**SUSQUEHANNA STEAM ELECTRIC STATION
RESPONSE TO REQUEST FOR ADDITIONAL
INFORMATION ON CHANGE TO TECHNICAL
SPECIFICATION SURVEILLANCE
REQUIREMENT (SR) 3.5.1.12
PLA-7125**

**Docket No 50-387
and No. 50-388**

Response to Request for Additional Information

Figure 1: ADS Valve, Actuator and Arrangement of Solenoids and Air System

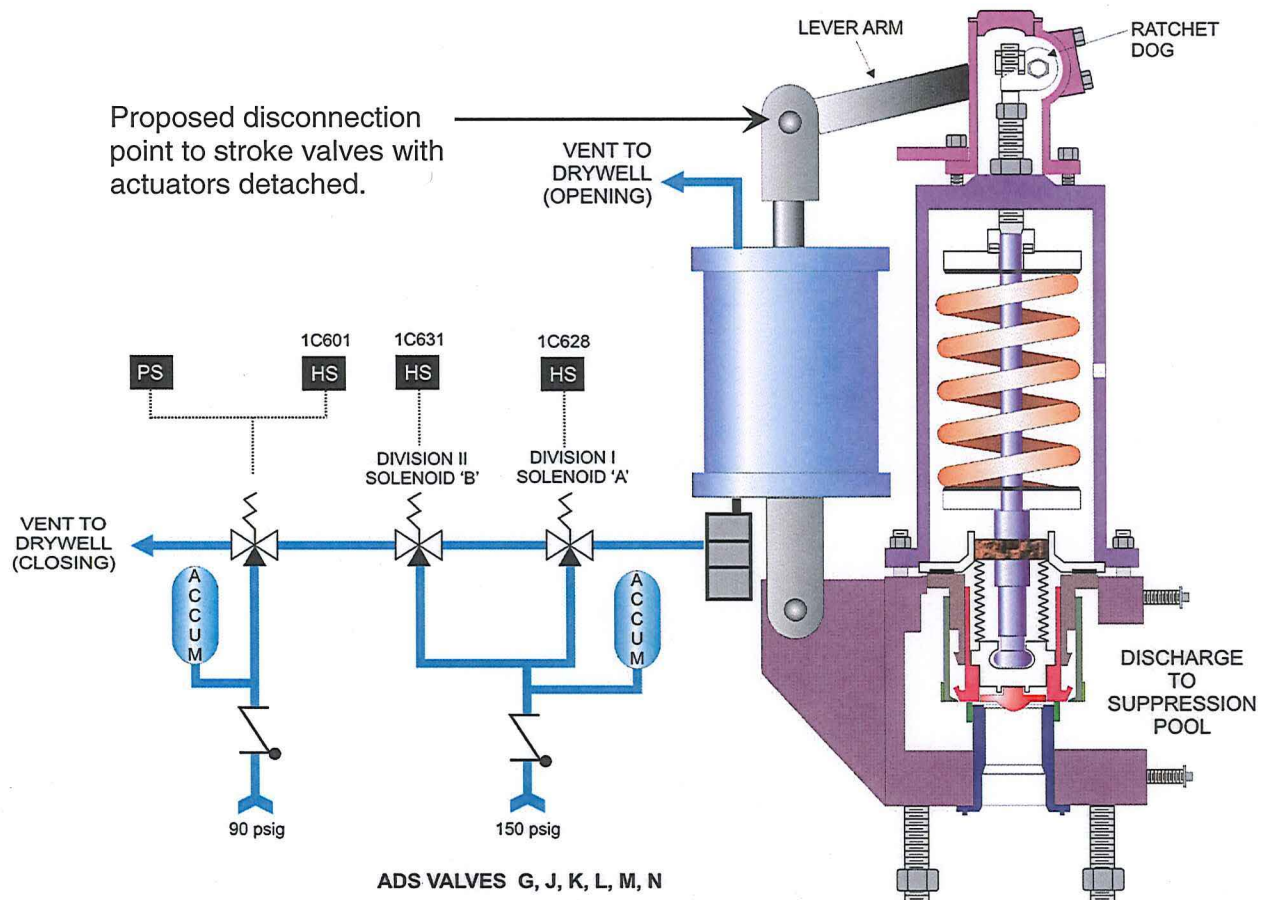
Provide drawings/sketches/piping and instrument diagrams depicting detailed design of the physical installation of the ADS valve (including information on the actuator such as number and arrangement of solenoids and air system arrangement) the licensee wants to disconnect from the positioner, so the staff can verify the ADS actuator is disconnected from the valve to ensure no damage is done to the valve seat or to the valve internals.

FSAR Figure 5.2-7 shows a simplified schematic. The figure below provides the requested information.

The proposed disconnection point to stroke actuators detached from the valve is shown in the figure above. There is no damage done to the valve seat or to the valve internals by the proposal.

Piping and Instrumentation Diagram (P&ID) M-141, Sheets 1 and 2, Unit 1, Nuclear Boiler, is in Attachment 4. There are six ADS valves in the A, B, C and D main steam lines. These are shown as ADS valves 1F013G, J, K, L, M, and N. A manufacturer's assembly drawing is also provided in Attachment 4.
